Technical Service BULLETIN

SQUEAK & RATTLE SERVICE TIPS

'00 MR2 Spyder

NVH
NV011-00

Instrument Panel Rattle Noise

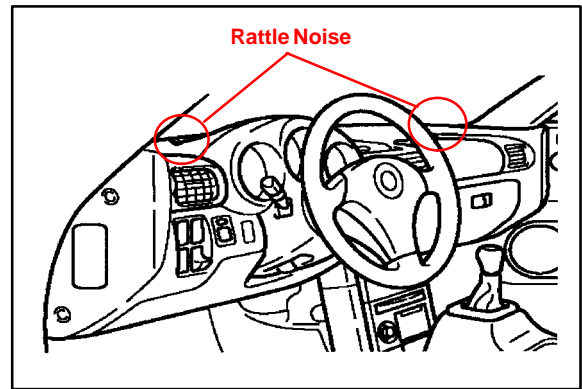
To eliminate a rattle noise from the upper instrument panel area:

1. Loosen the two (2) bolts on each side of the instrument panel.
2. While another technician pushes forward on the instrument panel, retighten the bolts as shown below.

**Passenger Airbag Cutoff Switch
Rattle Noise**

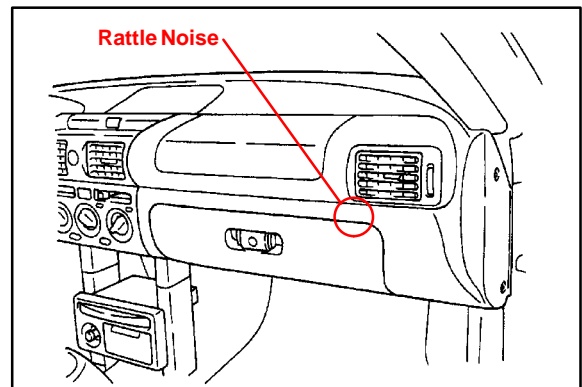
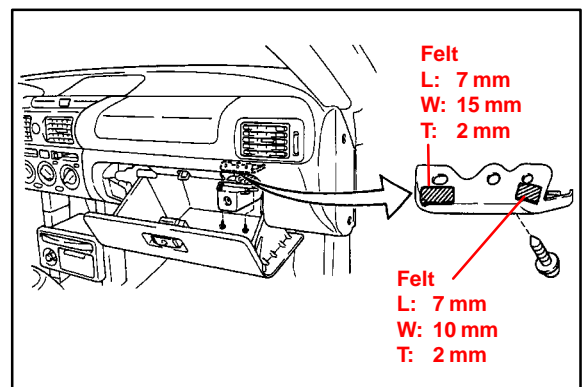
To eliminate a rattle noise from the airbag cutoff switch area:

1. Remove the two (2) bolts that hold the passenger airbag cutoff switch in place.
2. Cut two (2) pieces of felt in the following dimensions:

QTY	L	W	T
1	7 mm	15 mm	2 mm
1	7 mm	10 mm	2 mm

3. Fit felt pieces in the positions shown.
4. Reassemble in the reverse order of disassembly.

Convertible Top Fluttering Noise

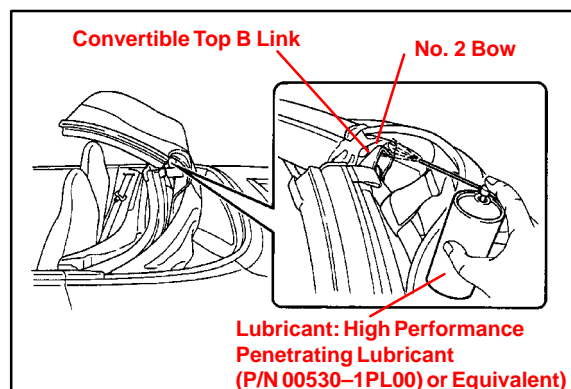
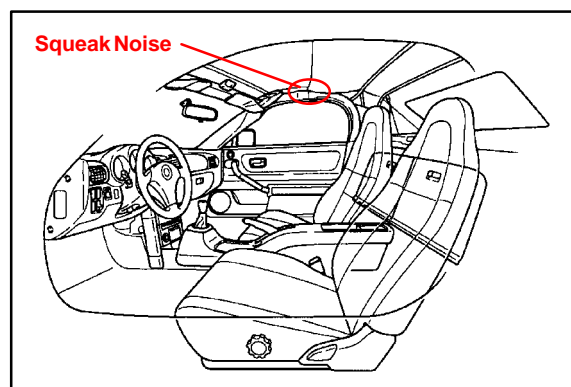
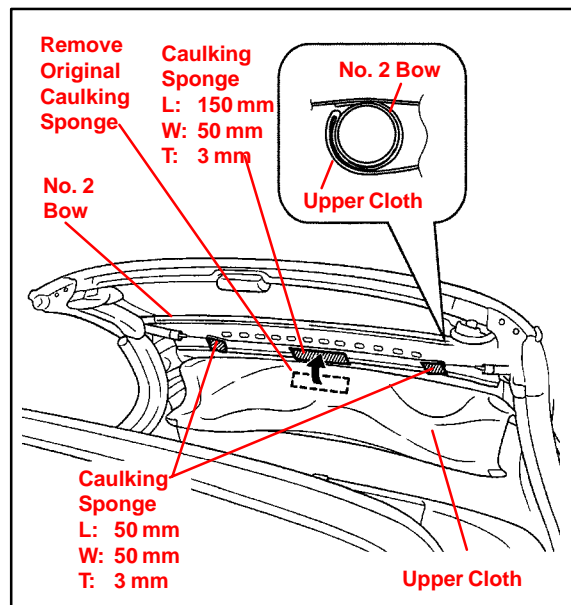
To eliminate a fluttering noise from the convertible top number 2 bow:

1. Remove the convertible top upper cloth (refer to the 2000 MR2 Spyder Repair Manual, pages BO-77 to BO-78).
2. Remove EPT Sealer (caulking sponge) from the center of the inner upper cloth (see illustration).
3. Clean area with Kent® Acrysol (or equivalent).
4. Cut three (3) pieces of EPT Sealer (caulking sponge) in the following dimensions:

QTY	L	W	T
1	150 mm	50 mm	3 mm
2	50 mm	50 mm	3 mm

5. Install EPT Sealer (caulking sponge) in the positions shown.
6. Reassemble in the reverse order of disassembly.

Convertible Top B Link Squeak Noise

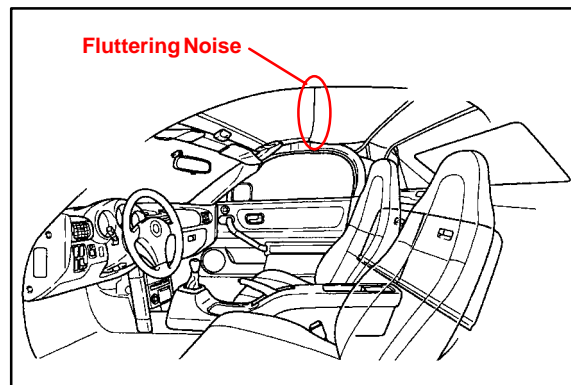
To eliminate a squeak noise from the convertible top B link:

1. Open the convertible top to a half-open position.
2. Spray High Performance Penetrating Lubricant (P/N 00530-1PL00) or equivalent in the area shown, being careful to avoid overspray on interior components.
3. Wipe off excess lubricant.

Luggage Compartment Lid Rattle Noise

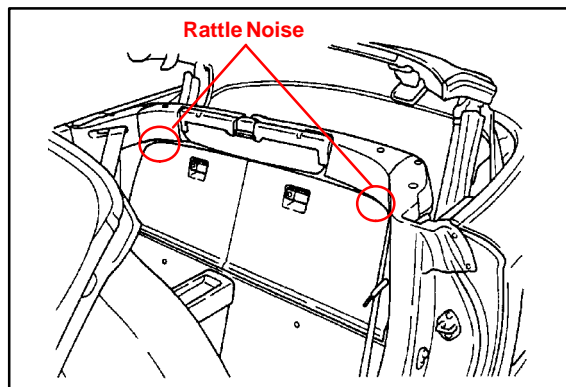
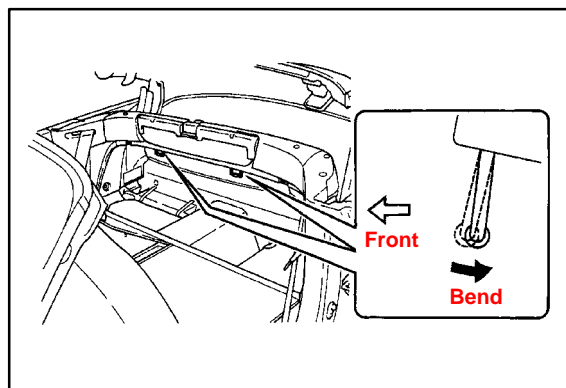
To eliminate a rattle noise from the luggage compartment lid:

1. Bend the luggage compartment lid striker approximately 3 mm rearward as shown.

Luggage Compartment Lower Rear Separator Trim Cover Rattle Noise

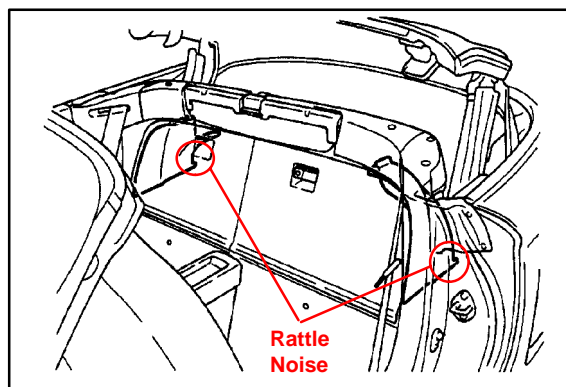
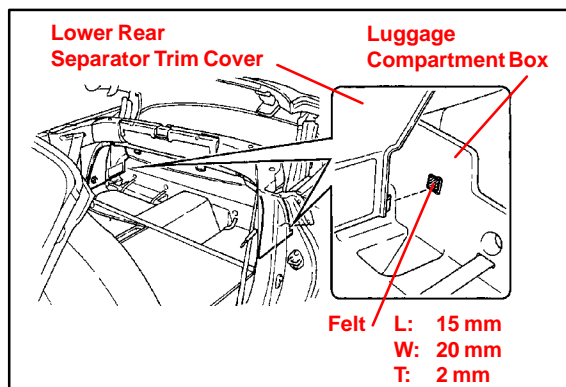
To eliminate a rattle noise from the luggage compartment lower rear separator trim cover:

1. Cut two (2) pieces of felt in the following dimensions:

QTY	L	W	T
2	15 mm	20 mm	2 mm

2. Install felt in the positions shown.

Cup Holder Buzz Noise

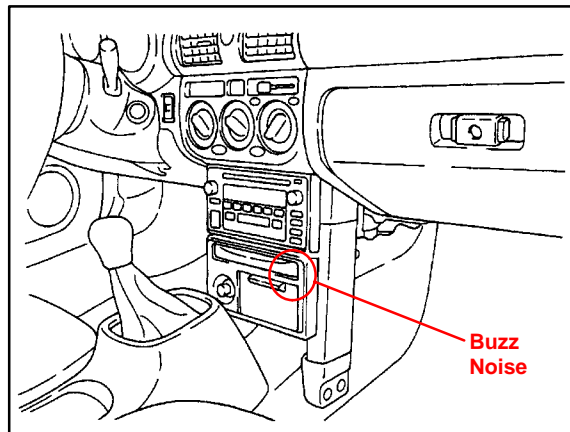
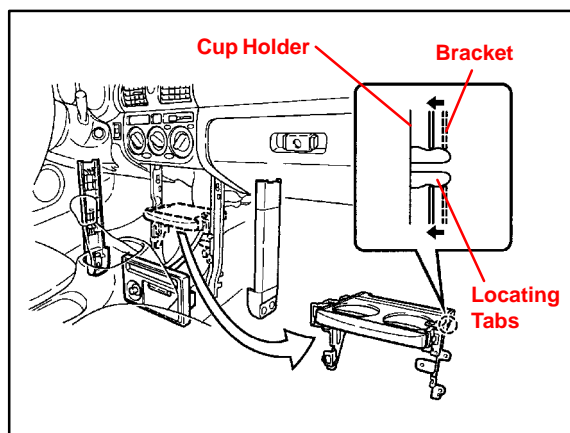
To eliminate a buzz noise from the cup holder area:

1. Remove cup holder assembly (refer to the 2000 MR2 Spyder Repair Manual, page BO-42).
2. Reposition cup holder brackets as shown.

It may be necessary to spread the locating tabs slightly for tighter fit.

Instrument Panel Lower Finish Panel Buzz Noise

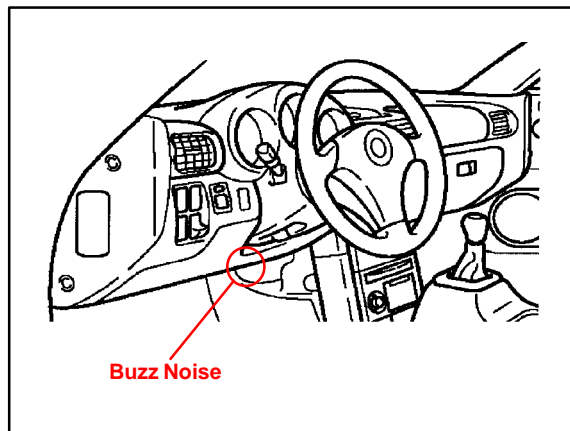
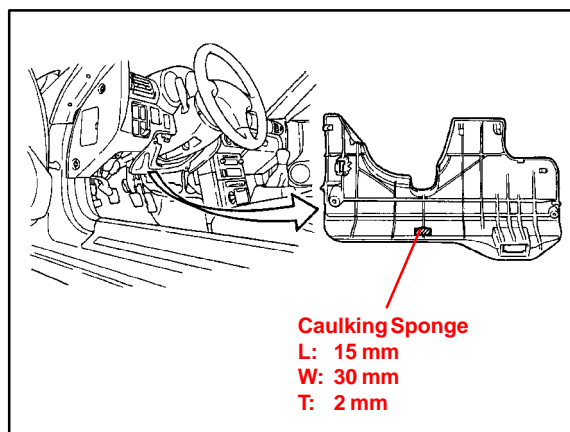
To eliminate a buzz noise from the No. 1 lower finish panel area:

1. Remove the No. 1 lower finish panel.
2. Cut a piece of EPT Sealer (caulking sponge) in the following dimensions:

QTY	L	W	T
1	15 mm	30 mm	2 mm

3. Install EPT Sealer (caulking sponge) in the position shown.
4. Reassemble in the reverse order of disassembly.

**Repair
Procedure**
(Continued)**Outside Door Handle Area Buzz Noise**

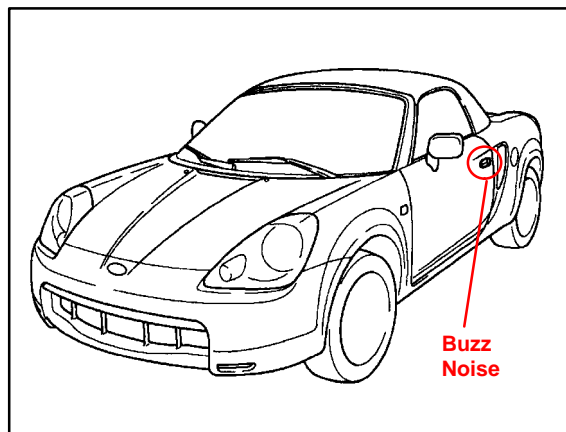
To eliminate a buzz noise near the outside door handle area:

1. Remove the door trim panel (refer to the 2000 MR2 Spyder Repair Manual, pages BO–12 to BO–13).
2. Cut a piece of EPT Sealer (caulking sponge) in the following dimensions:

QTY	L	W	T
1	19 mm	27 mm	10 mm

3. Install EPT Sealer (caulking sponge) on the power door lock connector in the position shown.
4. Reassemble in the reverse order of disassembly.
